IMM Commentary on 2026 AS Methodology

Presented to:

TAC

August 27, 2025

Significant uncommitted capacity available within 1 hour when PRC < 5GW

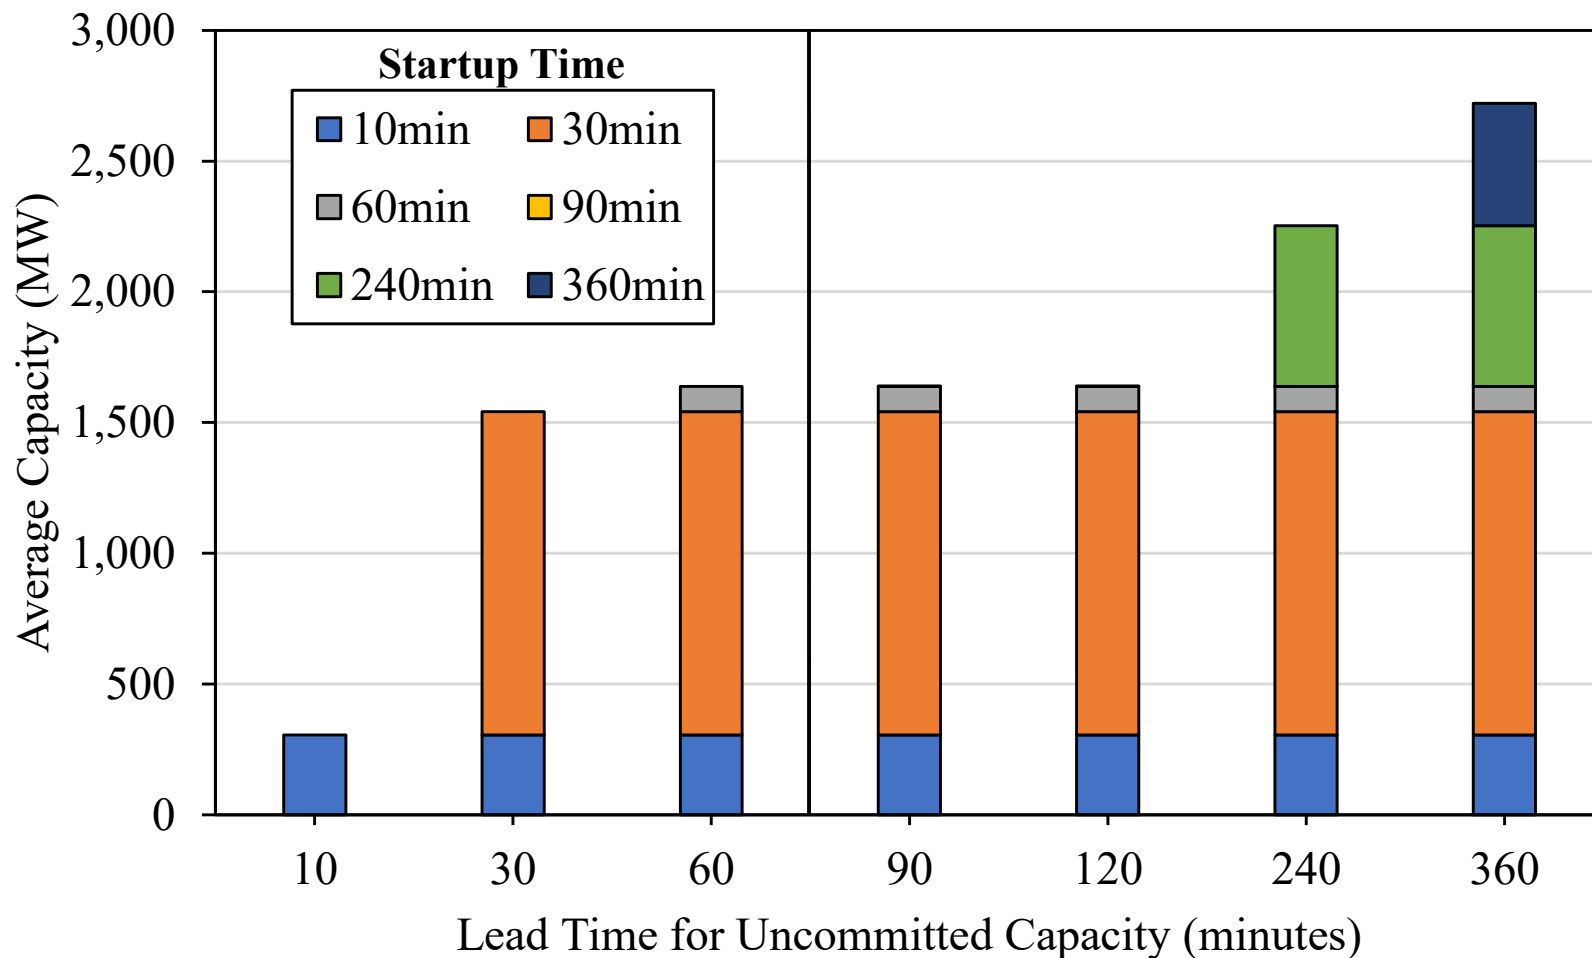
- A 1-hour time horizon is justified because much of the uncommitted capacity available during tight reserve intervals can be reached within 1 hour.
- The IMM considers the 6-hour time horizon to be unreasonable because it:

Avoiding a “Watch” is overly conservative and arbitrary

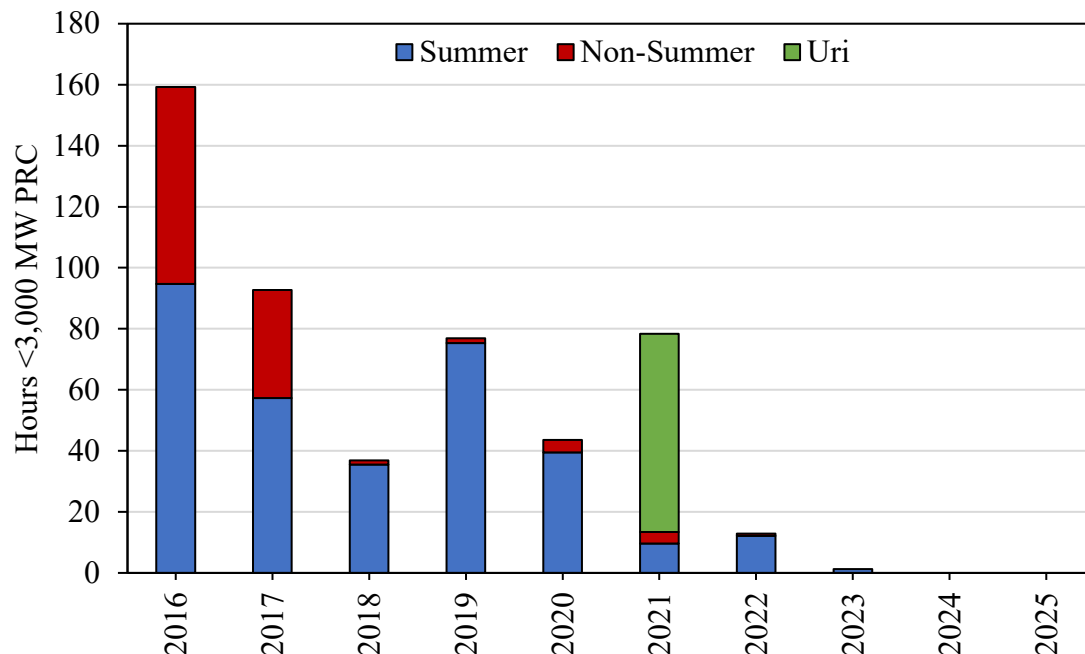
- Compared to the IMM’s proposed firm load shed threshold, IMM modeled results indicate ERCOT’s proposed “Watch” threshold would increase AS procurements by 40%-50%.
- Firm Load Shed threshold – 1,500 MW – justifications:
 - Commonly understood and utilized reliability planning standard
 - Clear definition and alignment within ERCOT Protocols – EEA Level 3 at 1,500 MW PRC
- Avoiding a “Watch” – $\text{Max}(\text{REG} + \text{RRS}, 3,000 \text{ MW})$ – is overly conservative
 - No clear definition of “Watch” – loosely tied to 3,000 MW PRC
 - REG+RRS constraint is even more conservative
 - It implies a 1/10 standard short on REG and RRS
 - This setting will overwhelm any threshold below 3,000 MW due the quantity of REG+RRS typically procured
 - Using minimum requirements for the REG+RRS component could be a reasonable compromise (e.g., largest single contingency)

3-hour time horizon eliminates excess capacity while maintaining reliability

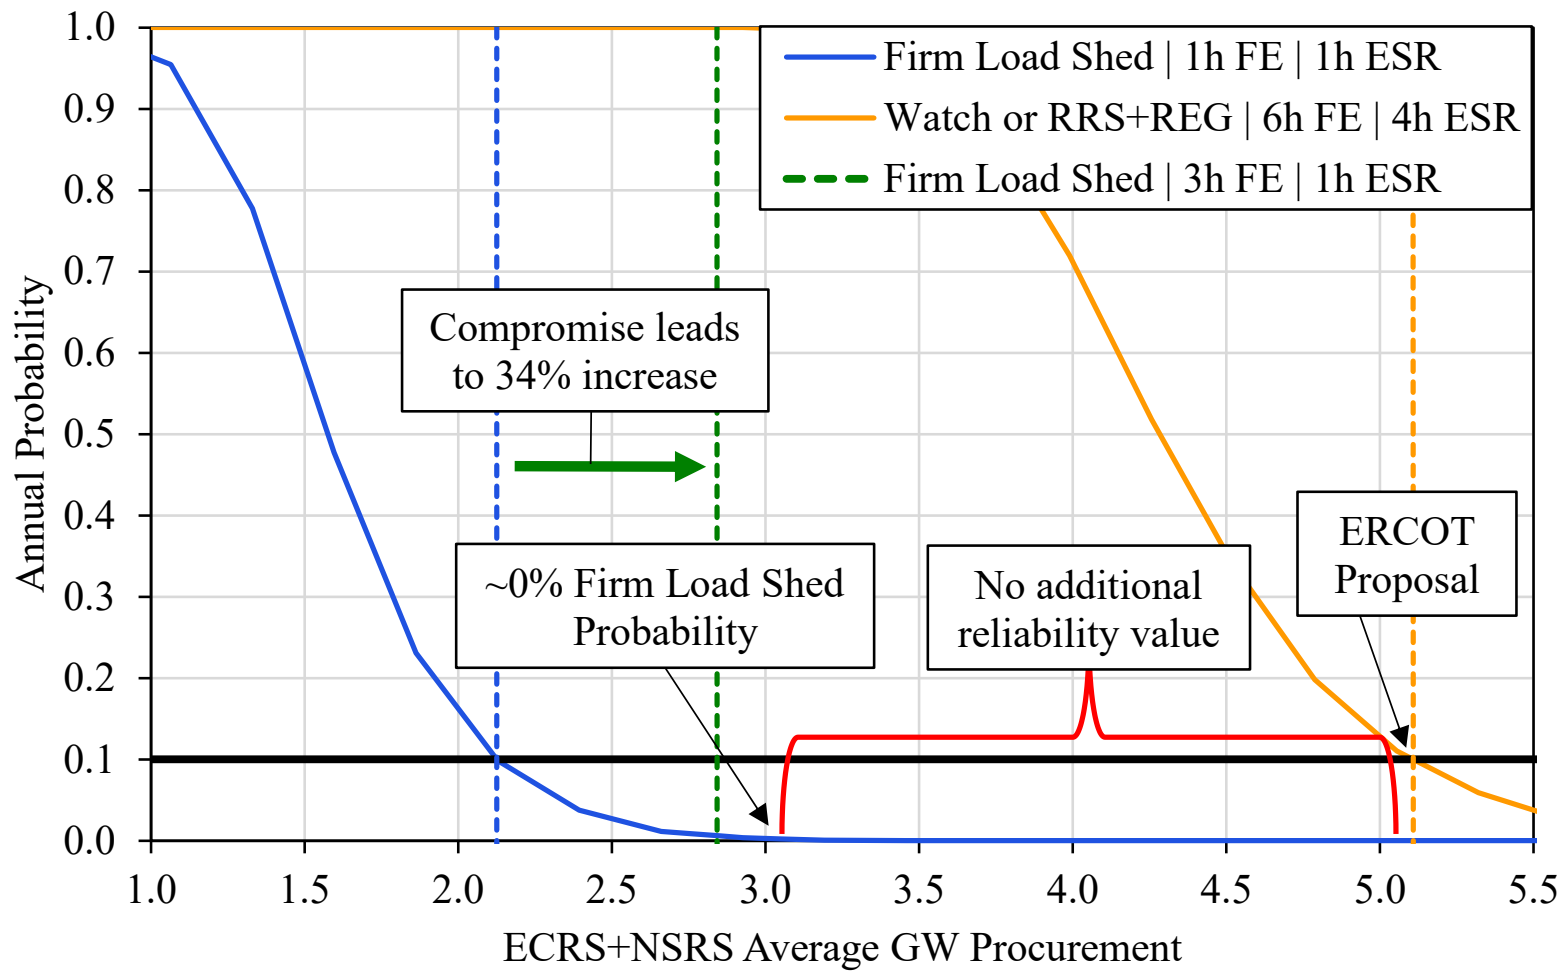
- As a compromise, the IMM recommends using a 3-hour forecast error time horizon
 - Relative to the IMM Base Case proposal, a 3-hour time horizon would require approximately 34% more AS capacity
- Using a 3-hour forecast error time horizon is supported by several justifications:
 - The compromise is closer to the IMM's preferred 1-hour time horizon – a reasonable timeframe for uncommitted capacity to respond to contingency events
 - Maintains a near 0% probability of entering firm load shed
 - Significantly reduces excess procurement associated with ERCOT's proposal
 - ERCOT has legacy operational experience using a 3-hour time horizon for NSRS from 2016-2022
 - No issues related to insufficient NSRS procurement during this timeframe
 - Longer Winter events, such as Winter Storm Uri, are not contingency events that NSRS is expected to cover
